1 Site Description

2.2 Outline permission – to which this reserved matters application relates:

2.3 As set out in the site description, this application was a cross-boundary application with Winchester City Council. A copy of the outline planning permission is appended at Appendix A and Appendix B shows the phasing plan for the wider MDA. This reserved matters application relates to Phase 8, which is entirely within the boundary of Havant Borough.

Figure 2: Extract from Reference Plan Footpaths, GTWVILLE_SW/LG/40 rev I, annotated to show connection points along the proposed BW15.

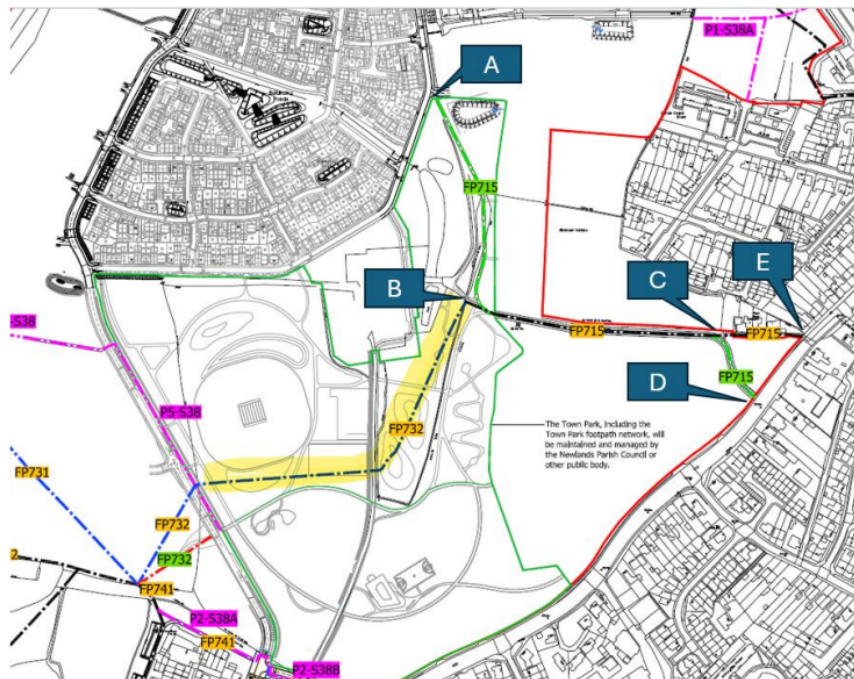
This will allow for the completion of the proposed BW15. This will need to consider the adoption of Plant Farm Crescent, or another method, to ensure that BW15 connects to another suitable element of public highway at both ends.

Hampshire County Council to carry out works on BW15, i.e. the road crossing. This may be in the form of a S278, or form part of a S38 should the proposed access road be put forward for adoption by HCC as the Highway Authority. I raise the query of adoption as the extent of carriageway adoption plan 4166-002 SK16-P01 ends immediately before the crossing over BW15.

Being that the site plan shows the crossing to be within the site area, it would seem that this carriageway adoption needs to extend to the site boundary and therefore incorporate the crossing.

Officer comment: *The PRoW, with the exception of the proposed road crossing is entirely outside this reserved matters application site. It is understood from HCC Highways that the adoption of the PRoW is imminent. It would not be reasonable to require the adoption of the PRoW as part of this application.*
